REPLACE THE 3-KW TQG MUFFLER HARDWARE

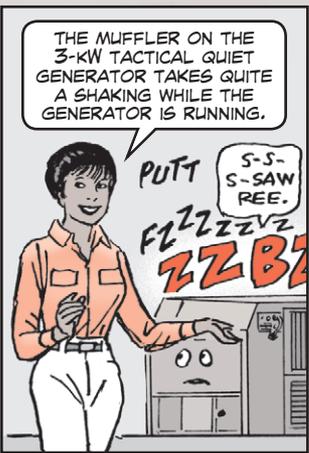
Replace the current muffler bracket mounting cap screws.

HOWEVER, WE TOLD YOU TO REPLACE THE CURRENT MUFFLER BRACKET MOUNTING CAP SCREWS—M6, 8.8—WITH CAP SCREWS—M6, 10.9—NSN 5305-01-303-5631... **THAT INFO IS BAD!**

It could be that this job has already been done on your generator. Check the top of the cap screws. If the top has a raised W.T 10.9 and is yellow, you're good. If it has a raised FS 8.8 and is black, you're bad. Replace the hardware!

THAT NSN BRINGS AN 8MM BOLT WHEN YOU NEED A 6MM BOLT. SO, ORDER BOLT, NSN 5305-01-300-6266, INSTEAD. **THAT'S THE RIGHT BOLT FOR THE JOB!**

Don't reuse the lock washers. Get new ones with NSN 5310-01-476-9079.

Add a new flat washer, NSN 5310-01-566-5242, to each cap screw. These washers are black and thicker than the old yellow washers
